6 The Project

This section provides an updated description of the Project which reflects the changes made in response to submissions received during the public exhibition of the EA.

6.2 Changes since exhibition of EA

Figure 6-6: Proposed connection substation and subdivision

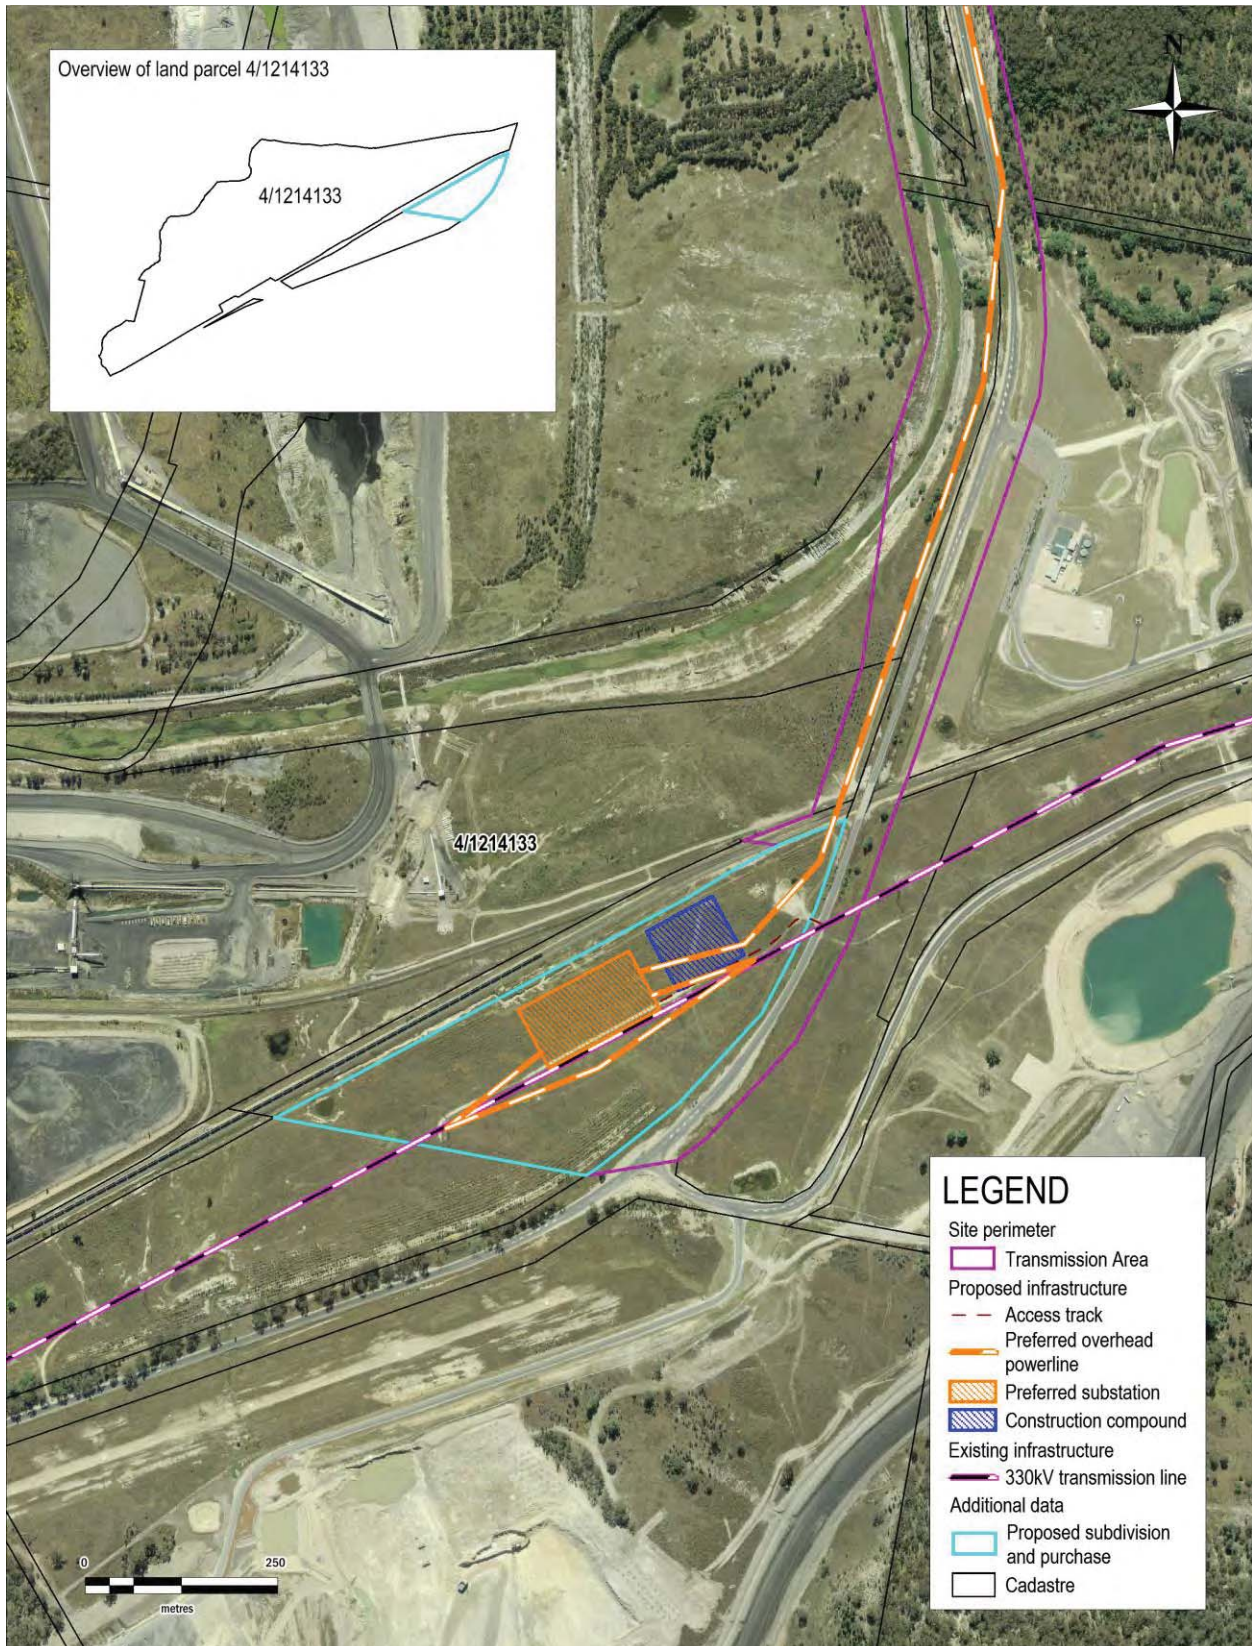
The connection substation has been relocated and is now adjacent to the existing 330kV transmission line from Wellington to Wollar on land currently owned by Ulan Coal Mine Limited (UCML). The Proponent was advised by UCML that the preferred and alternate options presented in the EA created challenges to ongoing and future operations at the mine. In consultation with UCML the connection substation was relocated to a more suitable location south of the rail line.

The new location of the proposed substation is shown in Figure 6-6. It is located on Lot 4 in Deposited Plan 1214133 (4/1214133). This proposal also seeks approval to subdivide the land shown in Figure 6-6 to create a new lot for the connection substation and associated facilities.

Figure 6-7: Changes to site access and access tracks

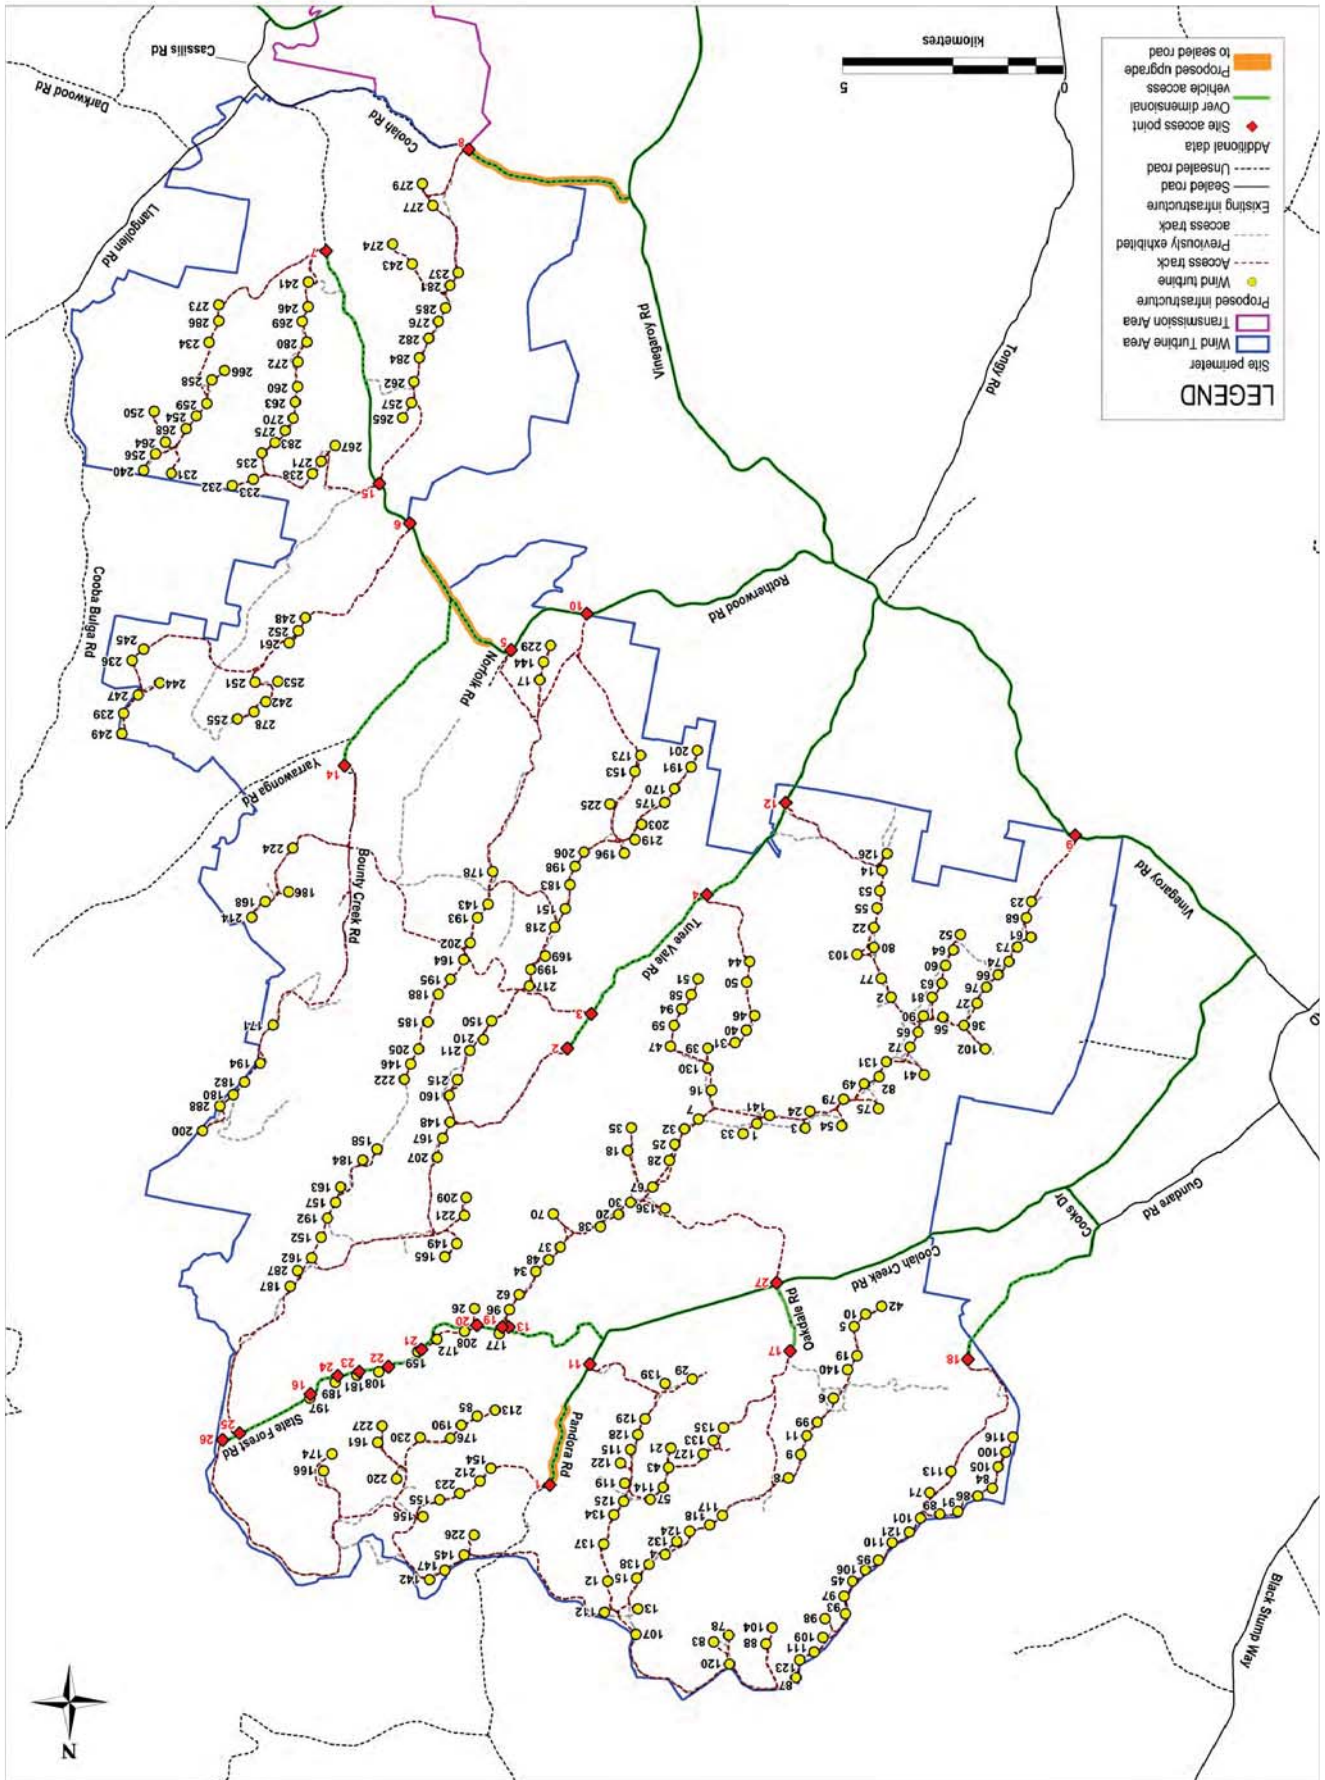
Access tracks across the wind farm have been updated to accommodate the relocation of other infrastructure such as substations and construction compounds. Additional site access points are proposed to address concerns about the location of construction compounds and traffic on local roads. Two new site entry points outlined in Table 6-5 will reduce the number of vehicle movements on Turee Vale Rd and Coolah Creek Rd and enable more suitable locations for construction compounds and batching plants.

Table 6-5: Changes to site access

Item No.	Comment
1	Access track from turbine 262 to Rotherwood Rd relocated to provide direct access to the proposed <i>Substation – Rotherwood</i> .
2	Track from <i>Substation – Rotherwood</i> to turbine 255 removed following design development.
3	Access track to turbine 179 not required after four turbines were removed.
4	Track to <i>Substation - Starkeys Creek</i> removed after substation was relocated.
5	Alternate access track to turbine 200 removed. Access from construction compound at Substation – Bounty Creek through to turbine 200 was redesigned to minimise total distance and vegetation clearing.
6	Access Track between turbine 222 and 158 removed to avoid native vegetation clearing.
7	Track to turbine 69 removed after the turbine was deleted.
8	Access track between turbine 66 and 52 removed to avoid vegetation clearing.
9	Access Track between turbine 131 and 60 removed and surrounding tracks simplified to reduce the overall footprint and vegetation clearing.

10	Access Track between turbine 7, 1 and 3 removed and surrounding tracks simplified to reduce the overall footprint and vegetation clearing.
11	Access tracks from Gundare Road and Site Entry Point 17 to the <i>Substation – Gundare (alternate)</i> no longer required after substation was removed.
12	Access track leading to the previous location for turbine 155 removed after the turbine was relocated.
13	New Access Track from Site Entry Point 10 (Rotherwood Road) to turbine 173 and turbine 17 to improve constructability of associated turbines.
14	New Access Track from Site Entry Point 9 to turbine 23 to improve constructability of associated turbines and minimise the number of turbine components delivered via Turee Vale Road.
15	New Access Track from Site Entry Point 1 to turbine 154 to improve constructability of associated turbines.
17	New Access Track from <i>Substation – Starkeys Creek</i> to turbine 217 and Site Entry Point 14 due to design development following the simplification of the Main Powerline and associated collection substations.

18	New Access Track from Site Entry Point 17 to <i>Substation – Gundare</i> to replace the track removed (Item no. 11) following design development after the simplification of the main powerline and associated substations.
19	New Access Track from Site Entry Point 27 to turbine 136 to provide direct access from batching plant to turbine locations and minimise the number of vehicle movements on public roads.
